Project Name: *

I-40 from I-440/US 64 (Exit 301) to just north of SR 1525 (Cornwallis Road)

Subject: **Modification Request for Section 404 Individual Permit, Section 401 Water Quality Certification and Neuse Riparian Buffer Authorization** for Interstate 40 Widening and Improvements from I-440/US 64 (Exit 301) to just north of SR 1525 (Cornwallis Road), including improvements to NC 42 and SR 1010 (Cleveland Road) in Wake and Johnston Counties, Federal Aid Project No. IMNHF-040-4(139)301; TIP Numbers I-5111 and I-4739, Division 5. Debit \$570 from WBS Element 42346.3.1.

PERMIT DRAWING
SHEET 3 OF 125
REVISED 11/19/2021

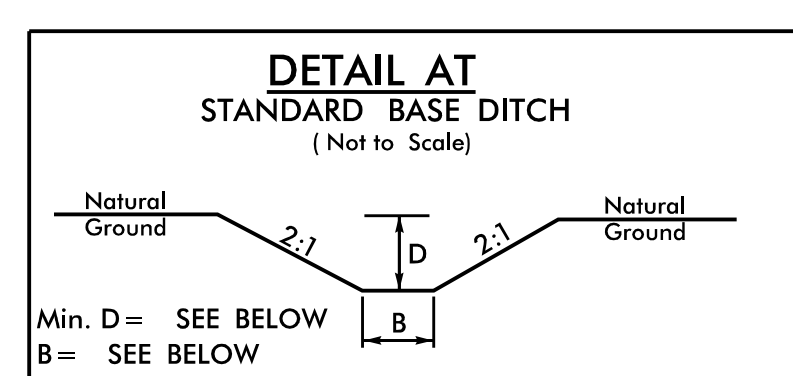
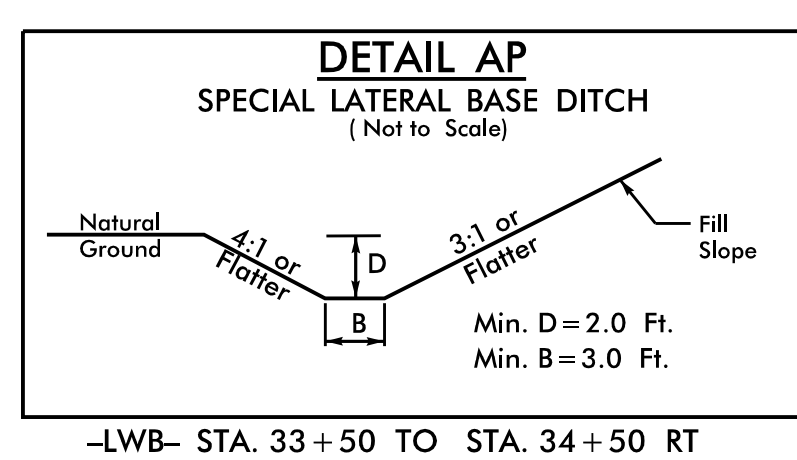
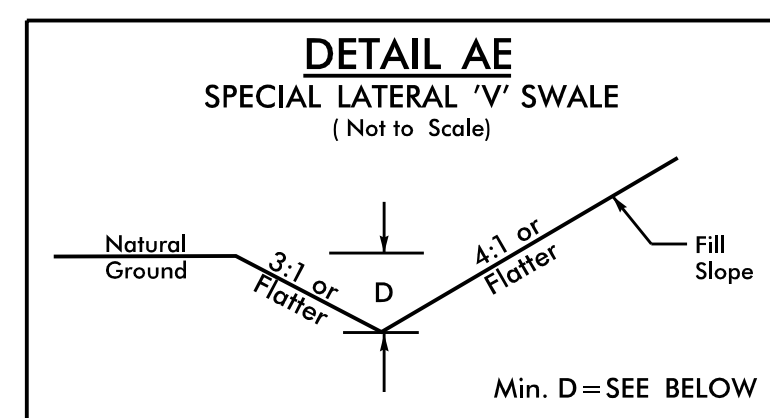
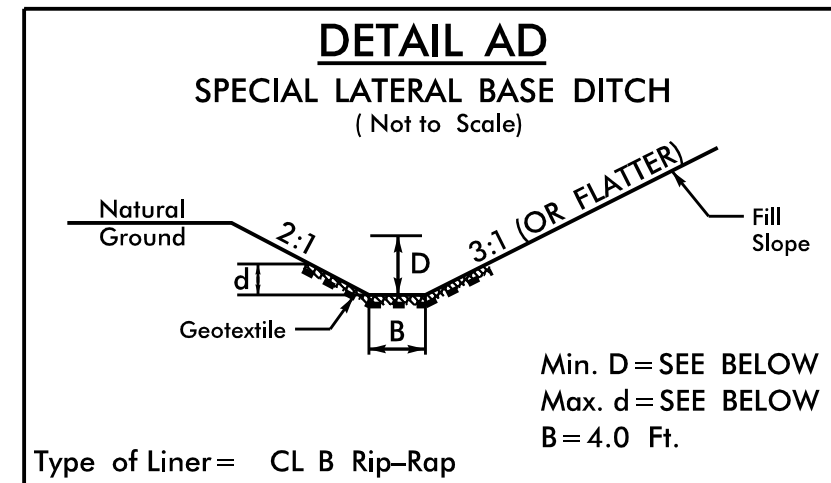
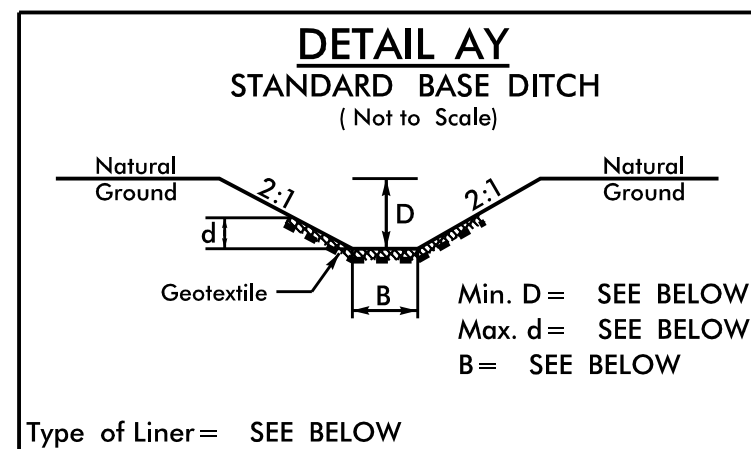
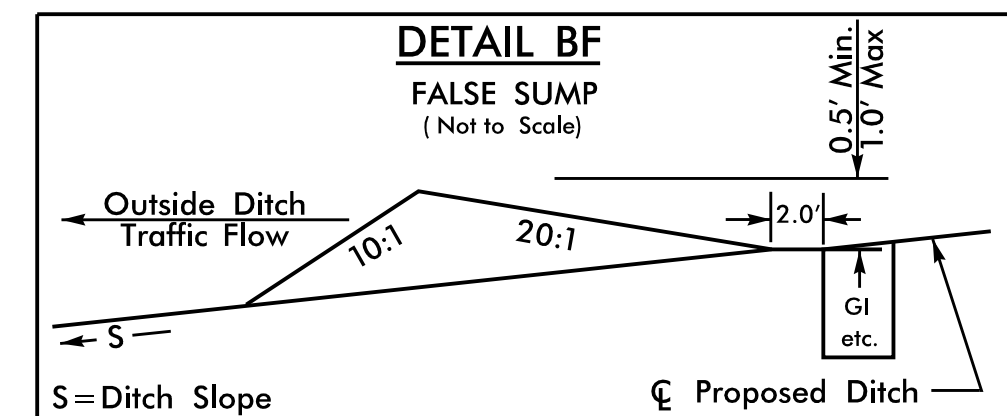
Site 1: There will be a reduction in stream impacts, as the contractor will not replace 2 @ 42" pipes, per NCDOT preference. Additionally, the noise wall will now be shortened along with the berm ditch.

- Permit Drawing 3: Ditch detail sheet
- Permit Drawing 9: plan sheet 4 without contours
- Permit Drawing 10: plan sheet 4 with contours
- Buffer Drawing 5: buffer plan sheet 4

10-31-2019 - ADJUST STATION RANGES FOR DETAIL BP AND DETAIL CF DUE TO PIPE ADJUSTMENTS.
01-03-2020 - UPDATED DETAIL AT WITH NEW BASE DITCH INFORMATION FOR -U- STA.63+81.
07-07-2020 - REVISED STATION RANGES TO INCLUDE STATION -Y3RPA- 32+43 RT
07-07-2020 - REVISED STATION RANGES FOR DETAILS AE,AK,BK,BL,BR,AND CG. ADDED DETAIL CO. REMOVED DETAIL BL.
03-29-2021 - REVISED INFORMATION FOR DETAIL -L1- STA.63+81 LT ON DETAIL AT.
06-08-2021 - REVISED STATION RANGE FOR DETAIL CF DUE TO SHORTENING OF MW3.
09-30-2021 - ADDED DETAIL CP
11-19-2021 - REVISED STATION RANGES FOR DETAIL CF TO REFLECT MW3 REVISED STATION.

PERMIT DRAWING
SHEET 7 OF 125

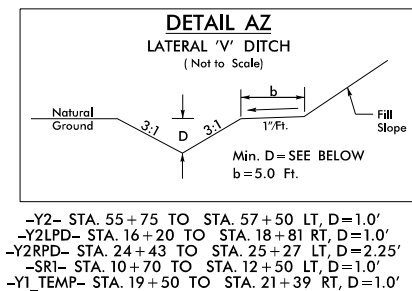
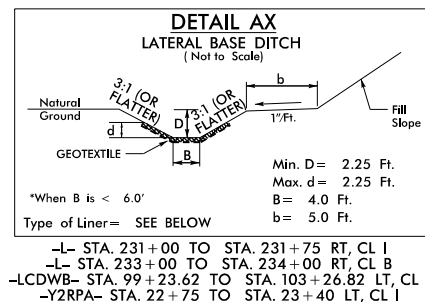
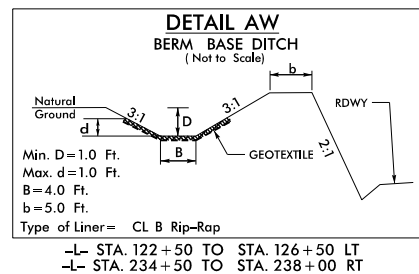
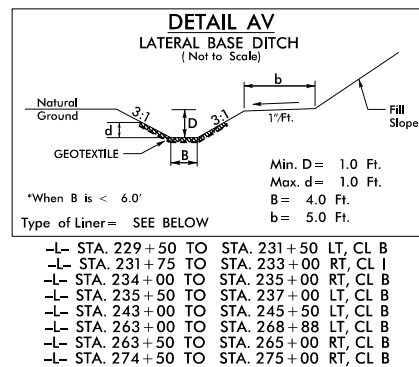
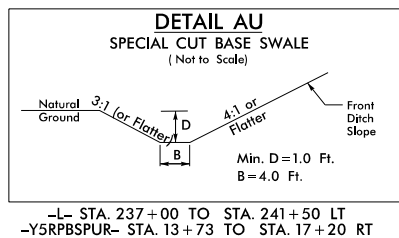
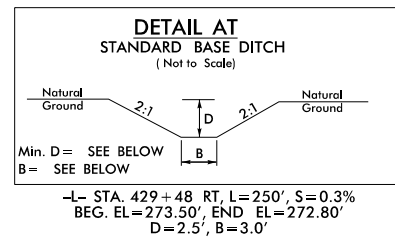
- 2) Outlet of SEQ: Design adjustments eliminated the need for a 54" WSP trenchless installation at -L- 115+00 to STA 118+00 by keeping stormwater along west bound side of the highway. The resulting pipe systems were slightly shortened during the field adjustment so that they would better align with the stream channel and prevent instability to the stream bank. Additionally due to construction accessibility and existing channel instability, rip rap was extended to the ROW line.

- Permit Drawing 7: Ditch detail sheet
- Permit Drawing 91: plan sheet 42 without contours
- Permit Drawing 92: plan sheet 42 with contours

- Permit Drawing 7: ditch detail sheet
- Permit Drawing 96: plan sheet 45 without contours
- Permit Drawing 97: plan sheet 45 with contours
- Permit Drawing 124: summary table
- Permit Drawing 125: summary table
- Buffer Drawing 51: buffer summary table
- Buffer Drawing 52: wetlands in buffer impact summary table

PERMIT DRAWING
SHEET 92 OF 125

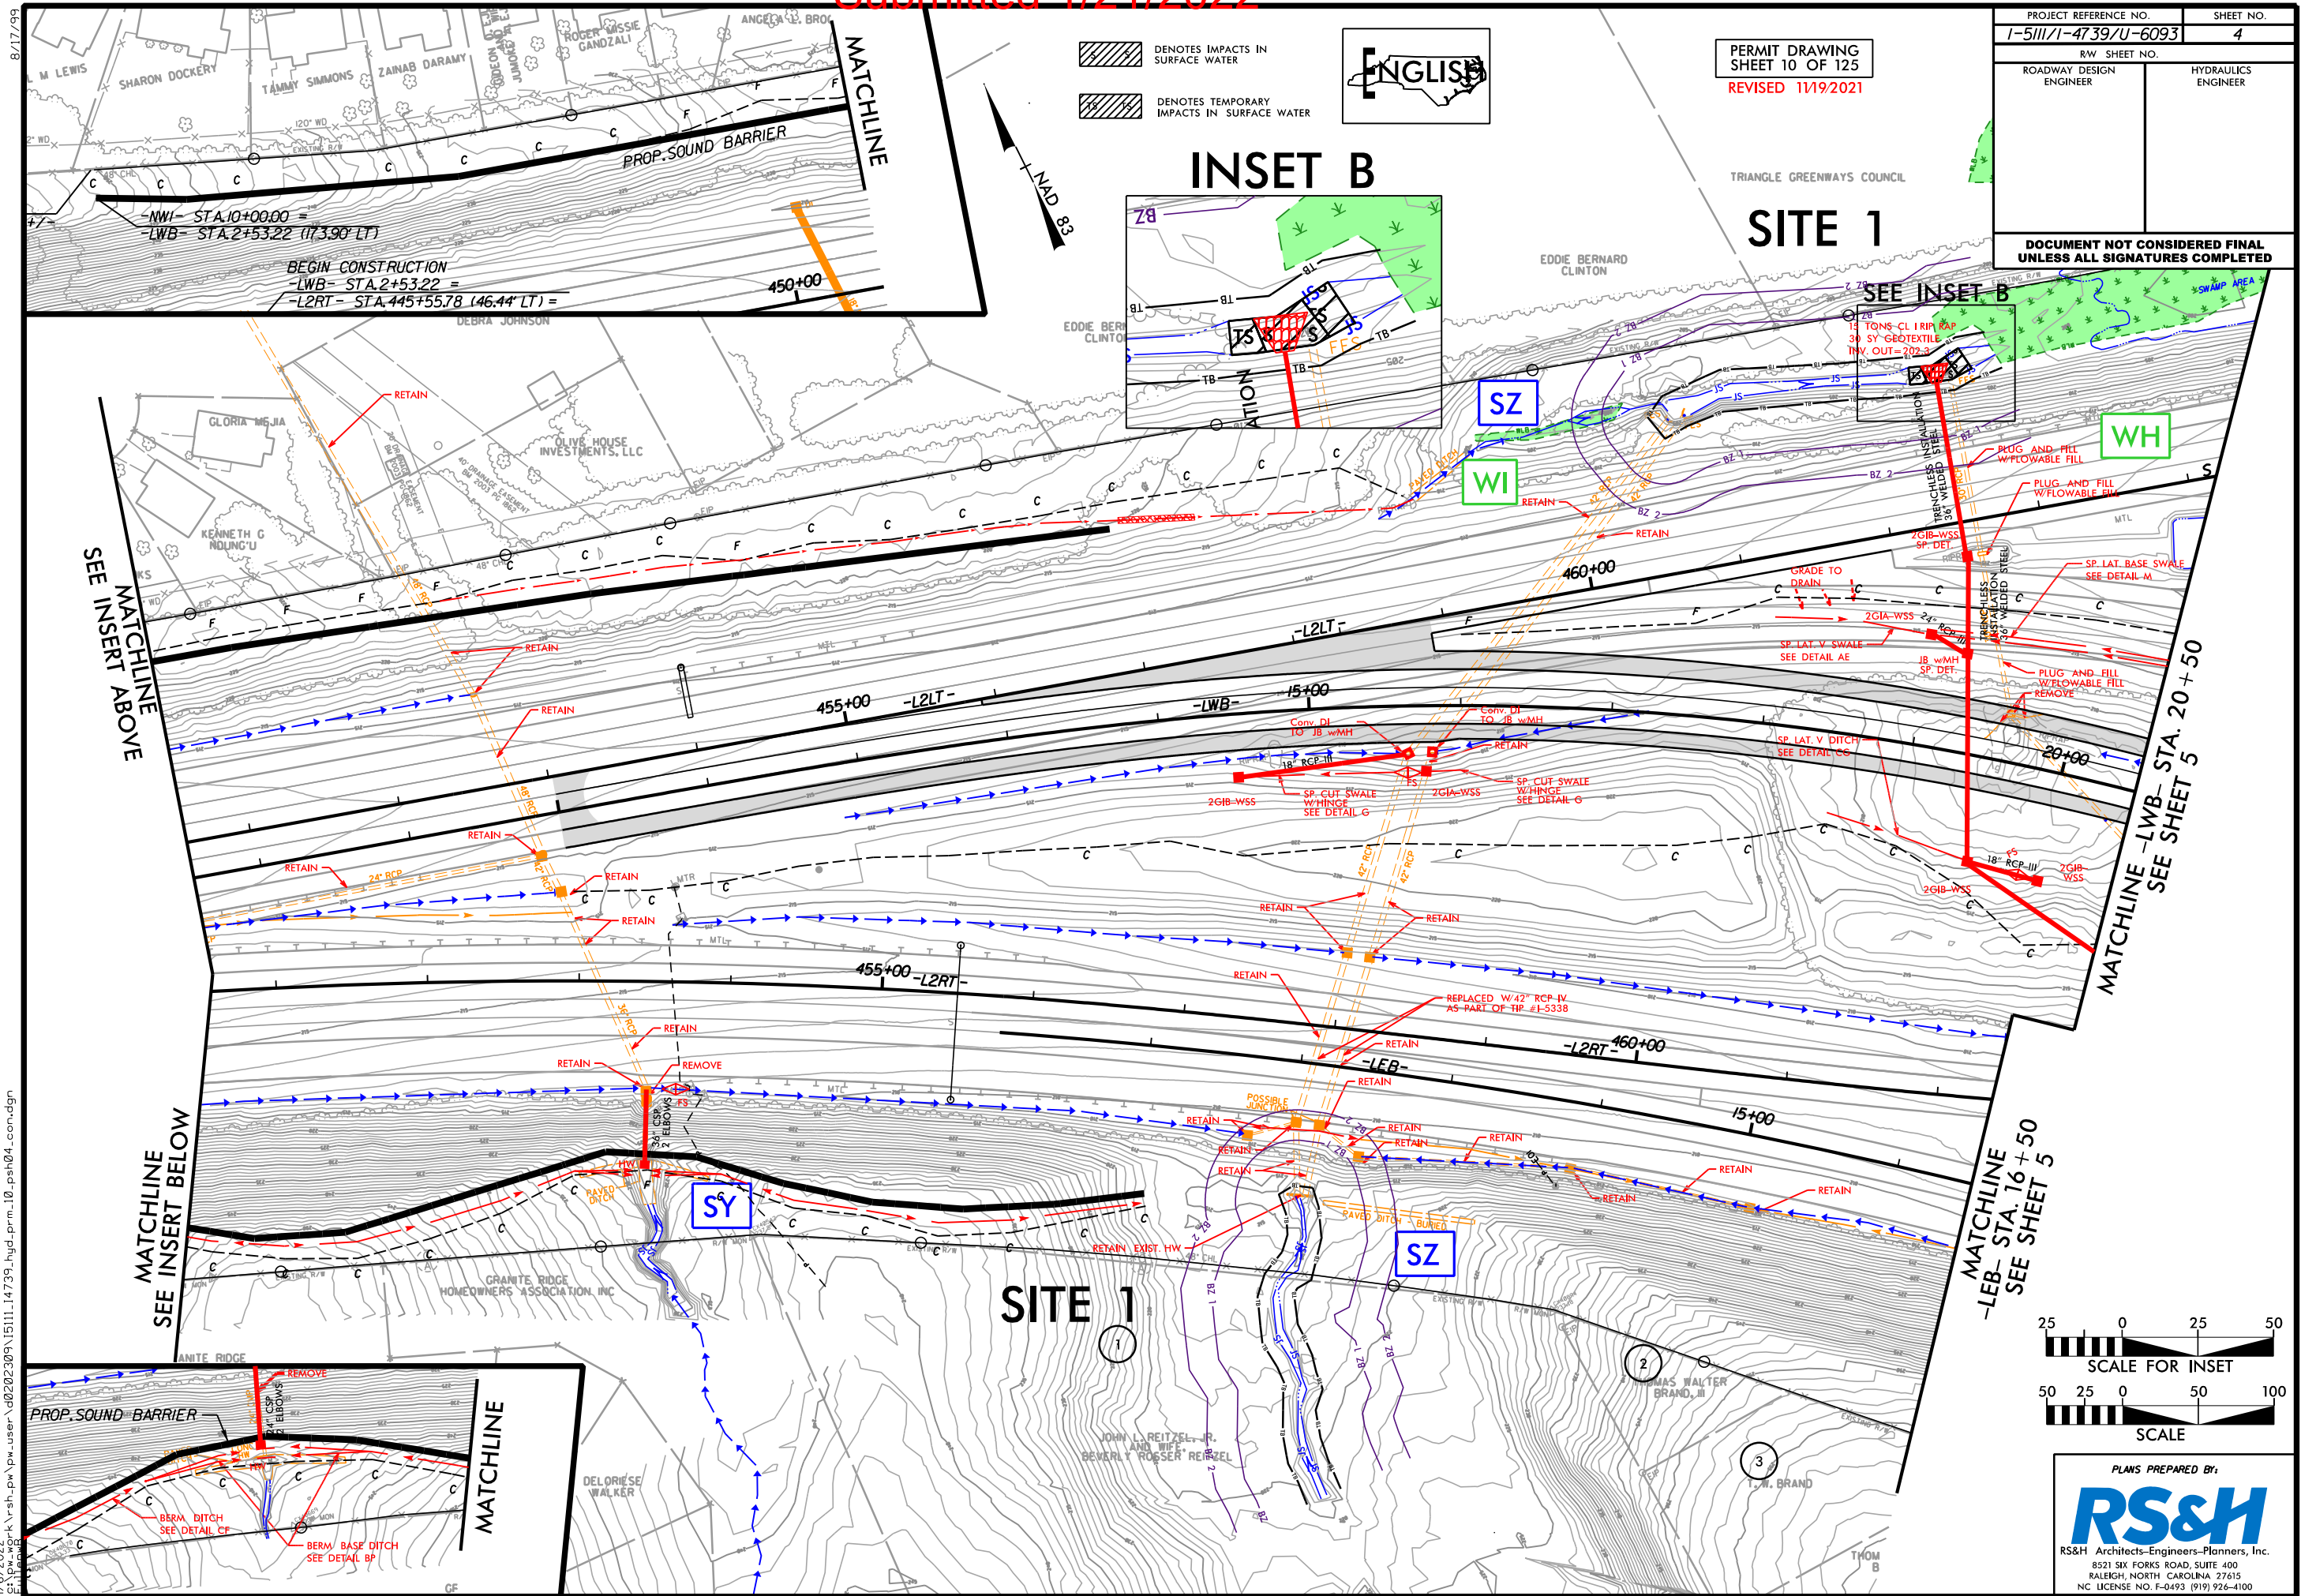
- 1) Wetland WEP(1) impacts were not accounted for originally while buffer impacts in the same area were permitted. Since this entire area was needed for construction access and for installation of erosion control measures, mechanized clearing in wetlands is now proposed for the portion of this wetland within the ROW.

- 3) In the upstream of SEQ (-L- RT east bound side), there was a temporary channel change previously permitted. But based on site conditions, the contractor and Division agreed that the site would be more stable if the stream was left in the temporary channel as opposed to shifting back to the original, thus the temporary stream impacts are now permanent. No additional increases to surface waters, wetlands, nor buffers are proposed in this area.

- 0.01 acre increase in mechanized clearing in wetland
 - 11 linear feet increase of permanent bank stabilization
 - 11 linear feet decrease of temporary stream impacts

BUFFER DRAWING
SHEET 7 OF 52
REVISED 11/19/2021

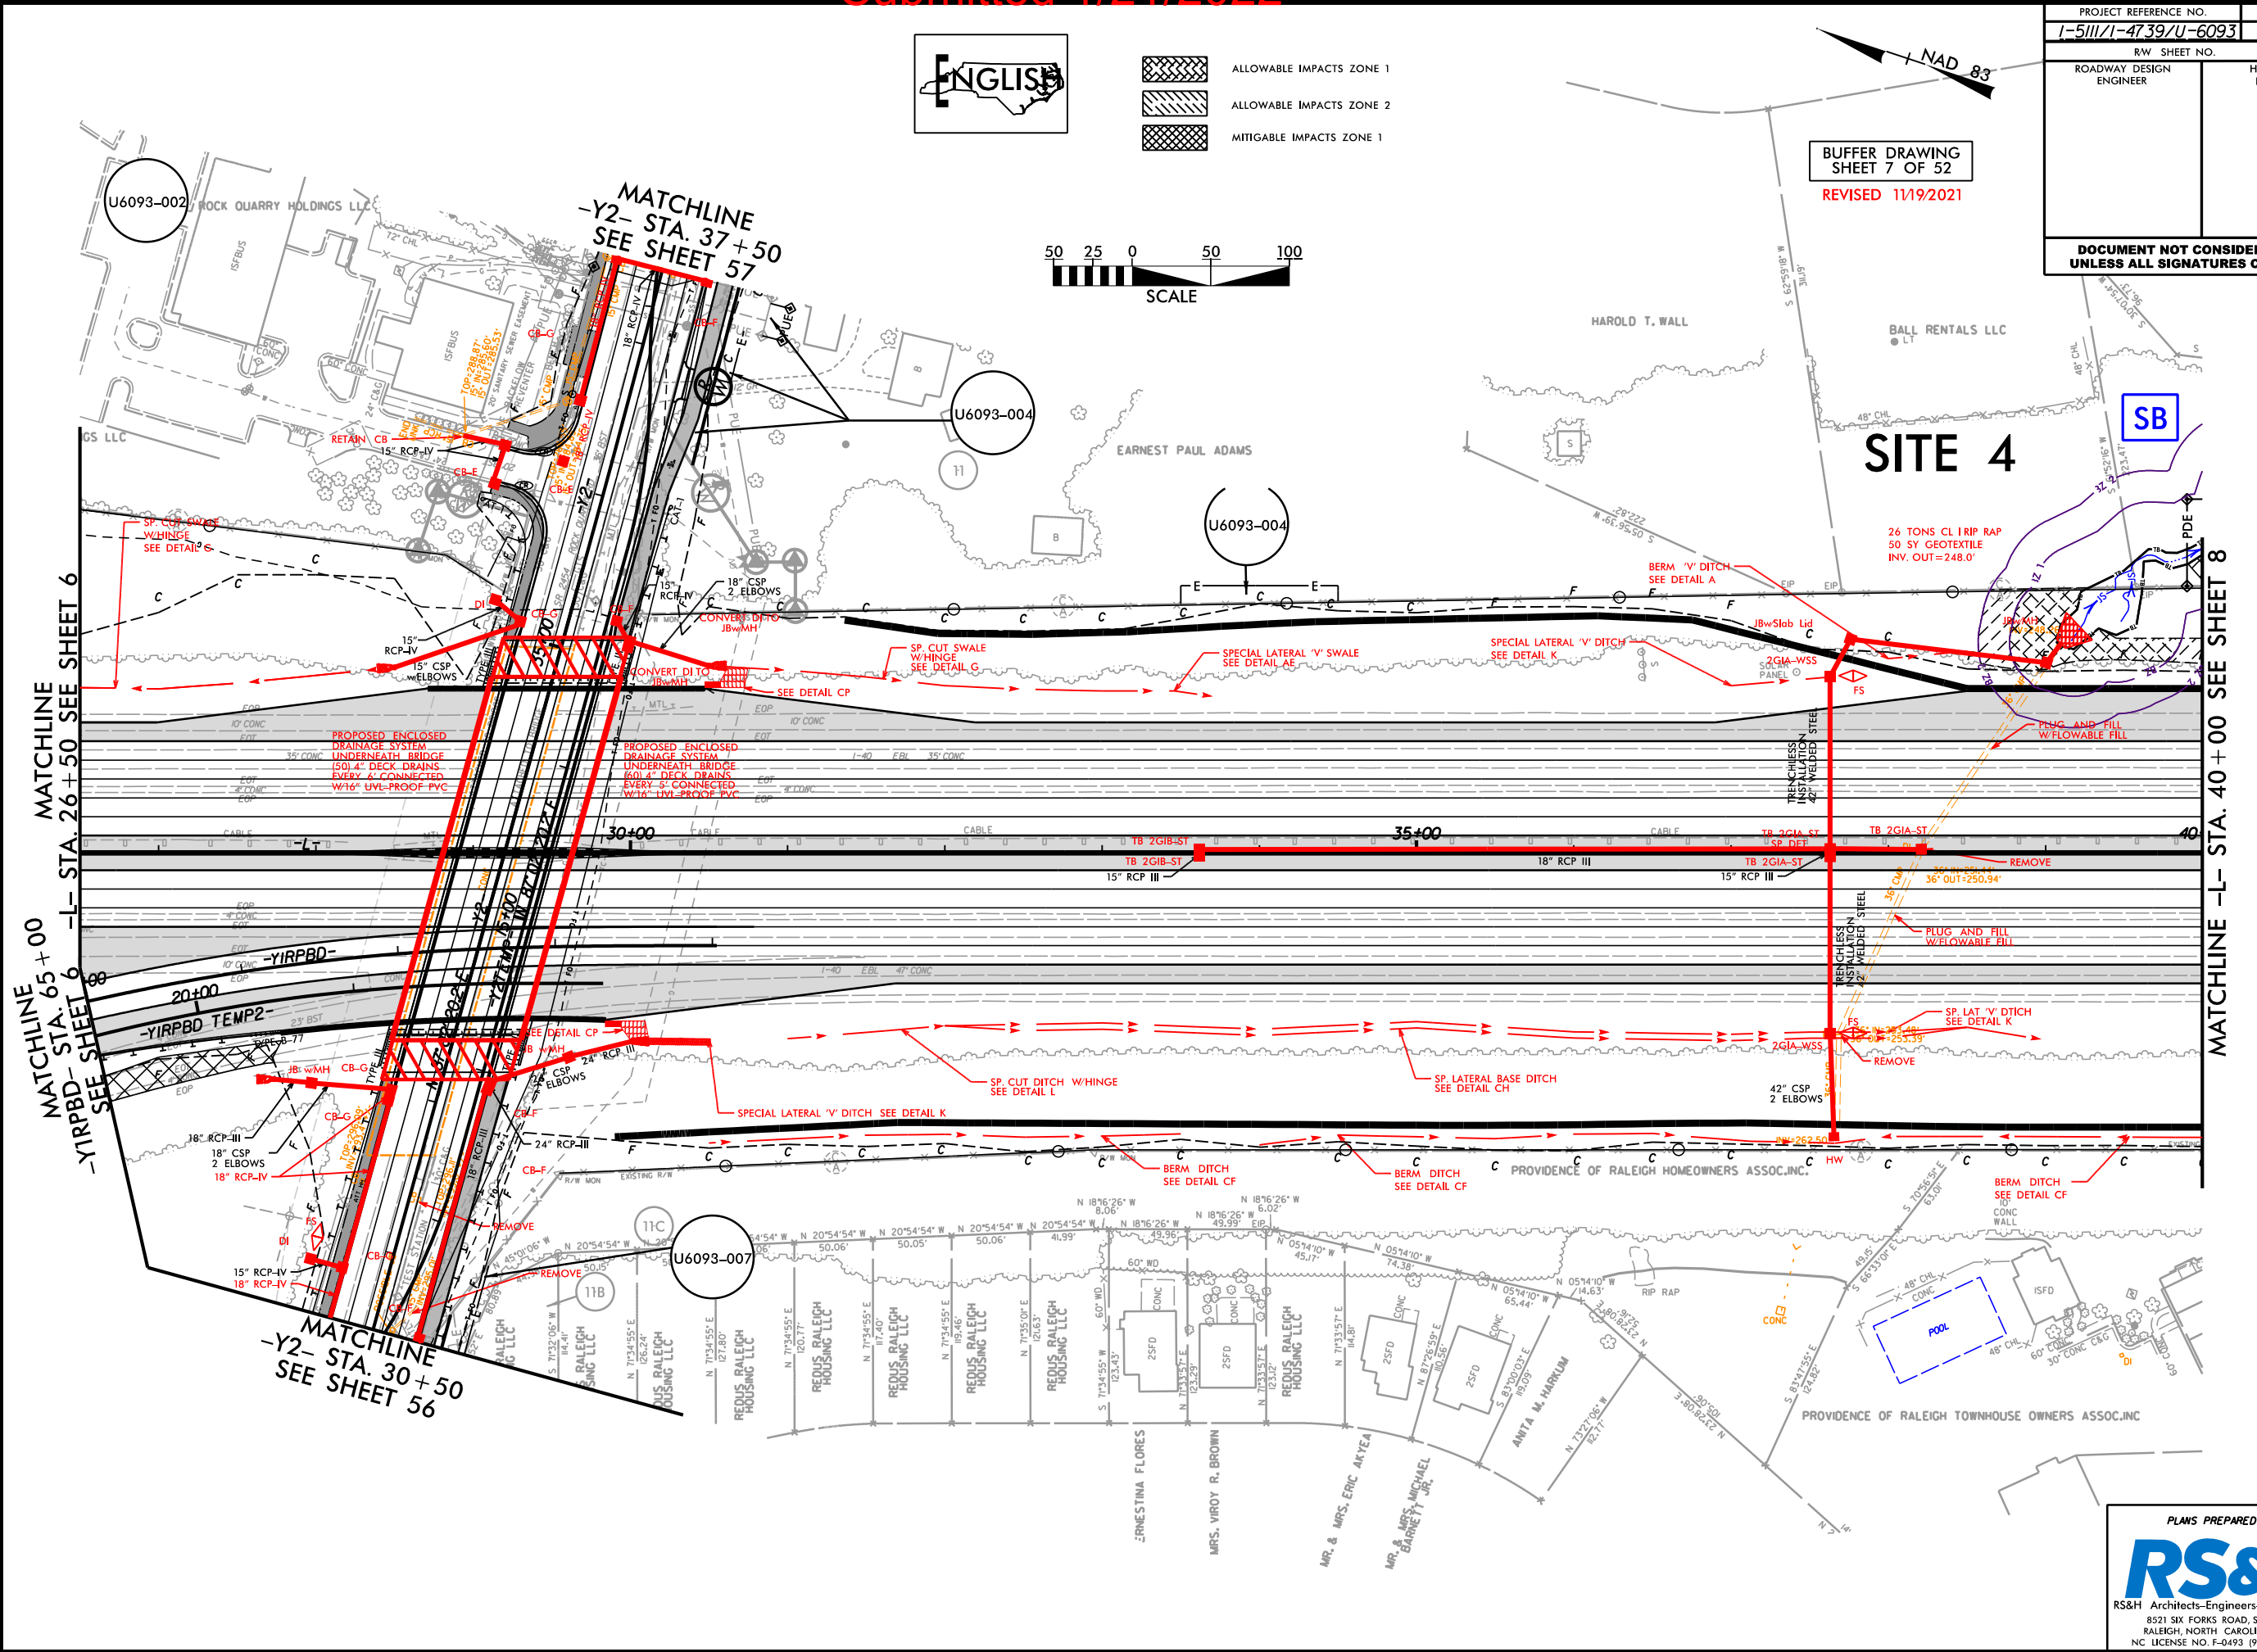
Site 4: Noise wall installation required a stormwater drainage system shift beyond the cut/fill line and outside of the noise wall (Plan Sheet 7), which resulted in moving the noise wall further to the east (Plan Sheet 8). Therefore, additional buffer impacts are proposed.

- 1,187 square feet increase in Allowable buffer zone 1 impacts
- 973 square feet increase in Allowable buffer zone 2 impacts
- 614 square feet increase in Mitigable buffer zone 2 impacts

- Buffer Drawing 7: plan sheet 7
- Buffer Drawing 8: plan sheet 8
- Buffer Drawing 45: buffer summary table
